LTR-NRC-20-43

Subject: Fuel Criterion Evaluation Process (FCEP) Notification of the 17x17 Advanced Debris Filter Bottom Nozzle (ADFBN) Design (Proprietary/Non-Proprietary)

**Fuel Criterion Evaluation Process (FCEP) Notification of the 17x17 Advanced
Debris Filter Bottom Nozzle (ADFBN) Design**

Figure 2: 17x17 Advanced Debris Filter Bottom Nozzle

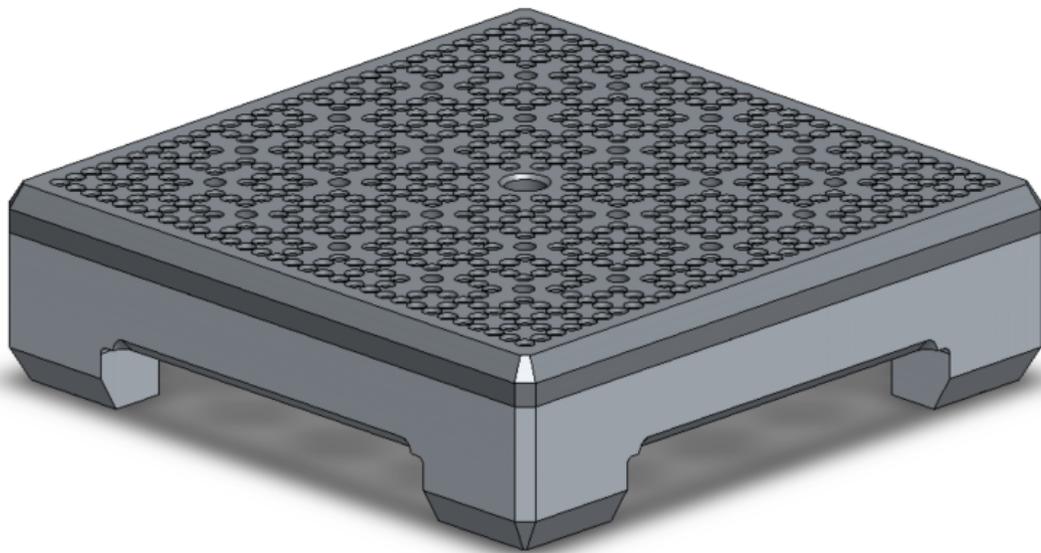
As shown in Figure 1, there is a gap between the bottom of the side skirts and the lower core plate that the SDFBN sits on which is a potential path for debris to travel around the bottom nozzle. Specifically, debris in the coolant flow under the bottom nozzle can pass under the side skirts and into the gaps between adjacent fuel assemblies where it can then travel into the fuel bundle region potentially leading to debris-induced fretting failures. Westinghouse closely tracks fuel failures and the current fuel designs with the Debris Filter Bottom Nozzle (DFBN)/SDFBN bottom nozzles have excellent performance with respect to minimizing debris-induced fretting failures. However, some recently observed debris-induced fretting failures have been seen on the outer rows of the fuel assembly indicating that debris may be bypassing the DFBN/SDFBNs, passing through the gaps between DFBN/SDFBNs and then into the fuel bundle region.

The 17x17 ADFBN design is shown in Figure 2 on the following page. This new advanced design focused solely on improving the side skirt design for the purpose of filtering debris to preclude it from bypassing the bottom nozzle. No other changes were implemented to the ADFBN design, including no changes to the bottom nozzle adapter plate, through which the majority of the RCS flow travels []^{a,c} The bottom nozzle side skirt was lowered so that it is just above the lower core plate. This reduced the gap below the side skirt from the current 17x17 SDFBN value of []^{a,c} The side skirts of the current 17x17 SDFBN design had the []^{a,c} gap to []^{a,c} Therefore, with the lowering of the side skirts for the 17x17 ADFBN design, it was necessary to []^{a,c} to allow for insertion, torquing, and crimping of the thimble screw adjacent to each pocket for each of the four side skirts.

The design of the 17x17 ADFBN lowered side skirt addresses several important interfacing requirements. []^{a,c} but also filter

the flow so as to trap any debris and preclude it from passing through this region of the bottom nozzle.

Lastly, the 17x17 ADFBN design was developed so that it would have the same []^{a,c}
as the existing 17x17 SDFBN. Meeting this requirement ensures that there is minimal impact in the
implementation of the new 17x17 ADFBN design.
